## HISTORIC AND DESIGN REVIEW COMMISSION

**HDRC CASE NO:** 2019-197  
**COMMON NAME:** 105 - 113 BROWN  
**ADDRESS:** 415 N MESQUITE ST  
**LEGAL DESCRIPTION:** NCB 568 BLK 17 LOT E 70 FT OF N 27.5 FT OF 10  
NCB 568 BLK 17 LOT W 30 FT OF E 100 FT OF 10  
NCB 568 BLK 17 LOT E 42.5 FT OF W 108.32 FT OF 10  
NCB 568 BLK 17 LOT E 39 FT OF W 65.82 FT OF 10 ARB 10A AT  
109 BROWN ST HS  
NCB 568 BLK 17 LOT E 39.7 FT OF 9  
NCB 568 BLK 17 LOT W 64.66 FT OF E 104.6 FT OF 9  
NCB 568 BLK 17 LOT E 99.78' OF W 104.18' OF 9 OR 9A  
**ZONING:** IDZ, RM-4  
**CITY COUNCIL DIST.:** 2  
**DISTRICT:** Dignowity Hill Historic District  
**APPLICANT:** Michael Perez/MP2 Urban Development  
**OWNER:** MP2 Urban Development  
**TYPE OF WORK:** Construction of five, multi-story residential structures  
**APPLICATION RECEIVED:** March 29, 2019  
**60-DAY REVIEW:** May 28, 2019  
**CASE MANAGER:** Edward Hall  
**REQUEST:**

The applicant is requesting conceptual approval to approval to construct five, multi-story residential structures on the vacant lots addressed 105 through 113 Brown Street and 415 N Mesquite, located within the Dignowity Hill Historic District. The lots are bounded by Brown Street t

**1 CONSTRUCTION PLAN**  
G0.01 SCALE 1" = 10'-0"

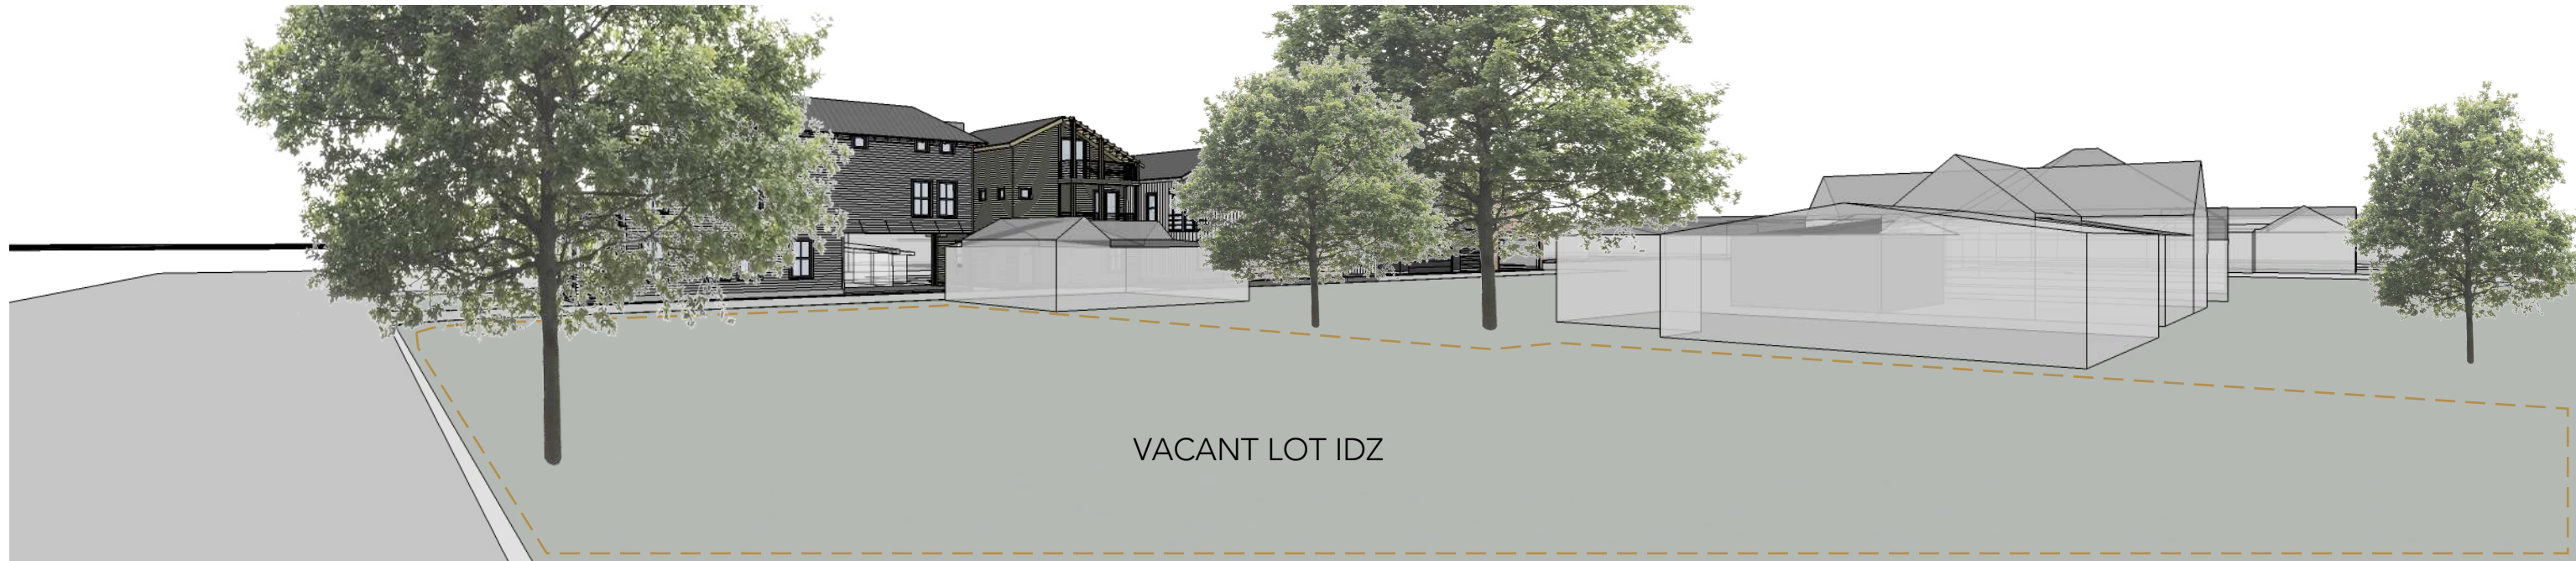
- s. **DRIVEWAY & VEHICULAR ACCESS** – The applicant has noted improvements and the widening of Brown Alley by six (6) feet to accommodate emergency vehicles. The alley surface will be asphalt, but the applicant has proposed dark shadow rock as the paving material for the additional six feet that is required for emergency vehicle access. Staff finds that a material that is found traditionally throughout the district, such as gravel or decomposed granite should be used.

- u. **LANDSCAPING PLAN** – The applicant has provided a site plan noting various site materials and the locations of proposed trees. Generally, staff finds the proposed landscaping plan to be appropriate; however, staff finds that a material that is found traditionally throughout the district, such as gravel or decomposed granite should be used, as noted in finding s. Additionally, a front walkway should be added to connect the proposed structure that is to address N Mesquite to the location of a public sidewalk, parallel to the street (a public sidewalk does not currently exist here). Staff finds the paver sidewalks on the alley facing structures to be appropriate.

- viii. That all mechanical equipment be screened from view at the public right of way as noted in finding r.
- ix. That the applicant propose either gravel or decomposed granite in place of the proposed black rock in the emergency fire lane, that a front walkway be installed in front of the proposed structure on N Mesquite and that the proposed carport feature wood construction as noted in findings t and u.
